# SERVICE BULLETIN

411A

Piper Aircraft Corporation

Subject: Stabilator Torque Tube Bearing Block Attachment Fitting Rivet Replacement

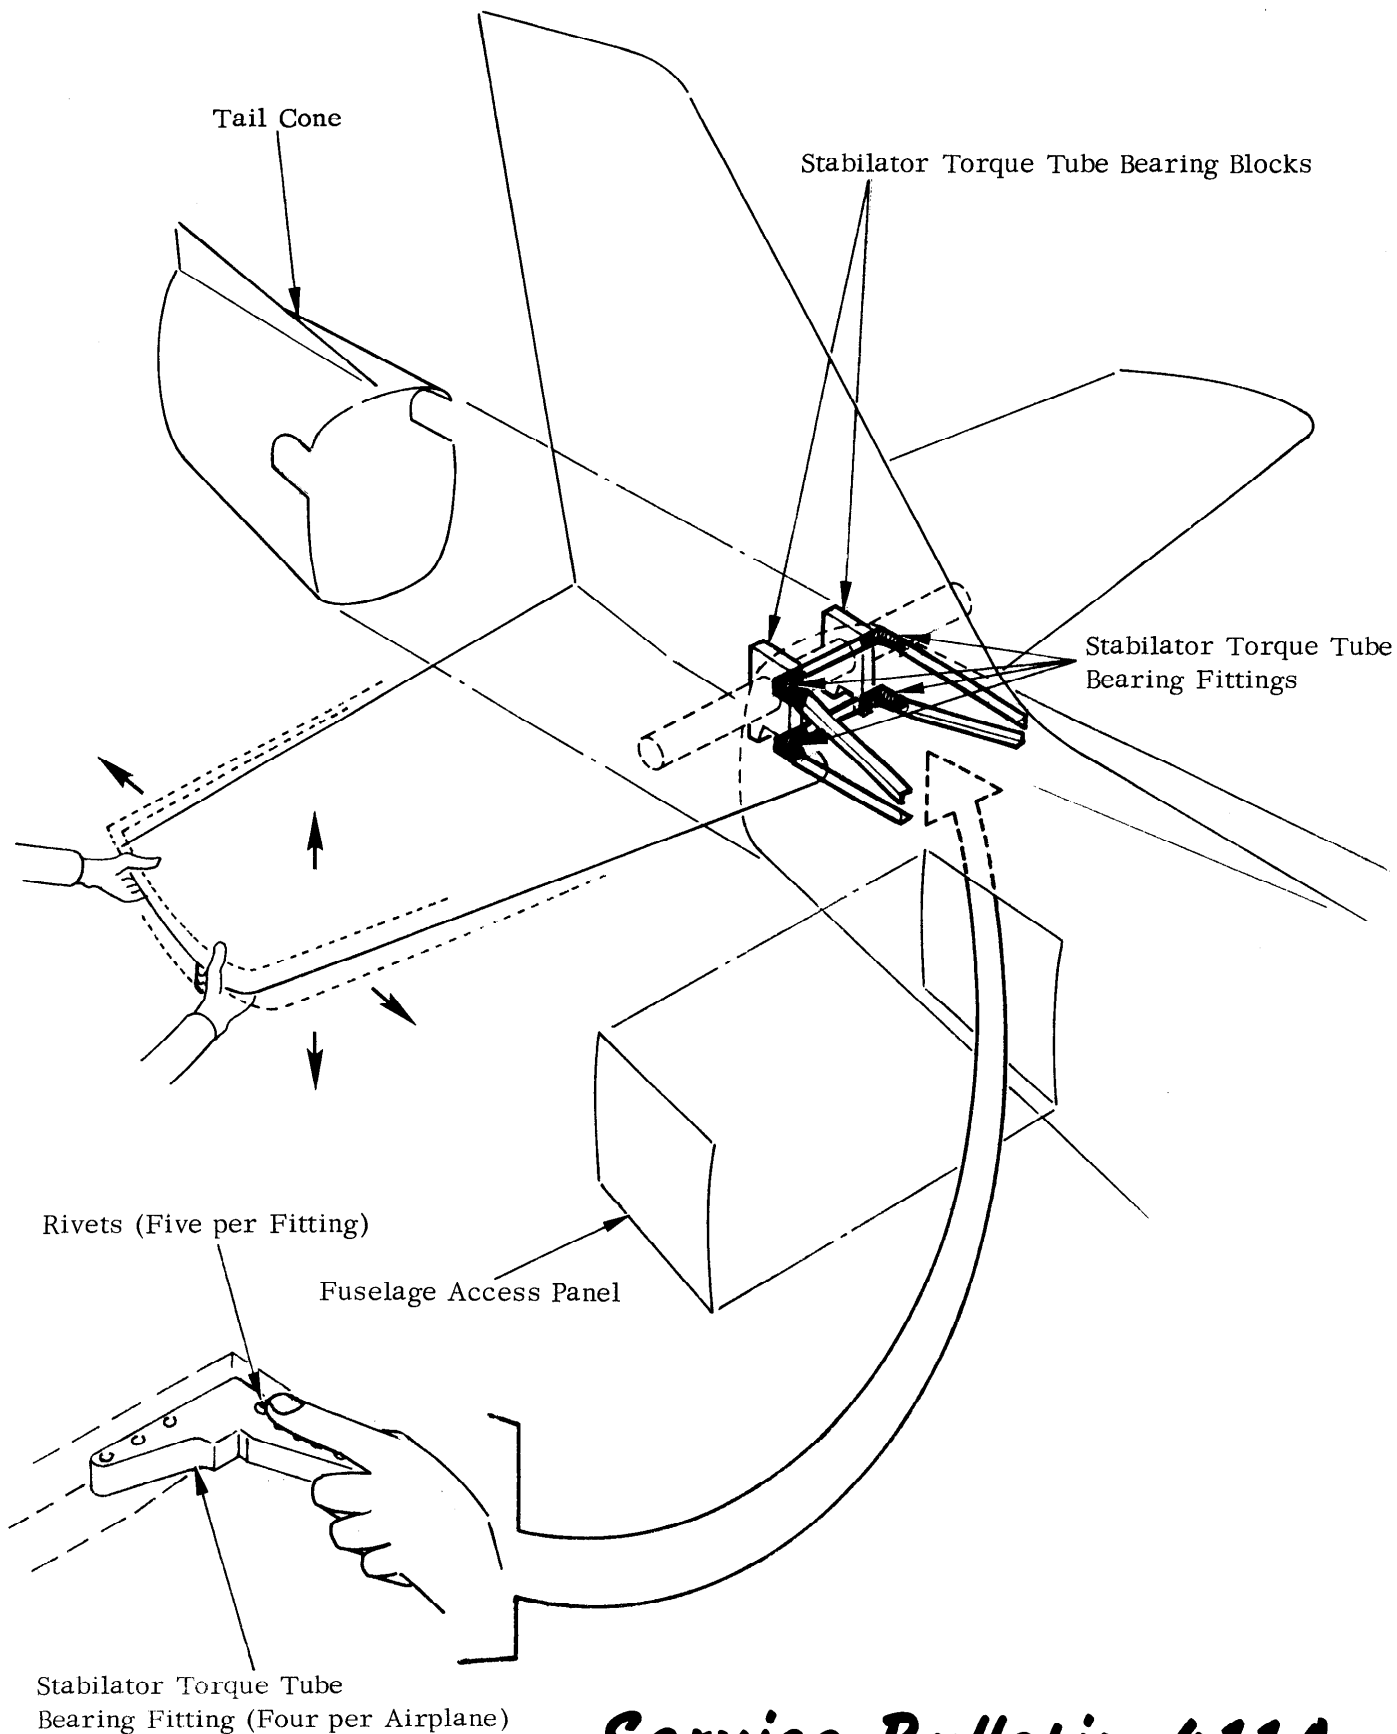
Purpose: Information has been received by the factory describing movement and/or noise in the area where the stabilator assembly joins the fuselage. It has been determined that the above described condition may have been caused by one of the following (refer to attached sketch for a pictorial description of the affected areas):

1. Stabilator torque tube bearings not firmly seated in the stabilator torque tube bearing blocks.
2. The holes in the stabilator torque tube bearing upper and lower fittings may be enlarged.

2. Simultaneously (with Step 1, above), have another person check closely for movement and/or noise in the area described in Purpose, above (the attached sketch illustrates a recommended method of detecting movement in the stabilator torque tube bearing fittings area).
3. If there are no indications of movement and/or noise, no further action is required (other than log book entry).
4. If there is movement and/or noise in the area described in Purpose, above, immediately contact the Customer Services Department, Piper Aircraft Corporation, Lock Haven, Pennsylvania 17745.
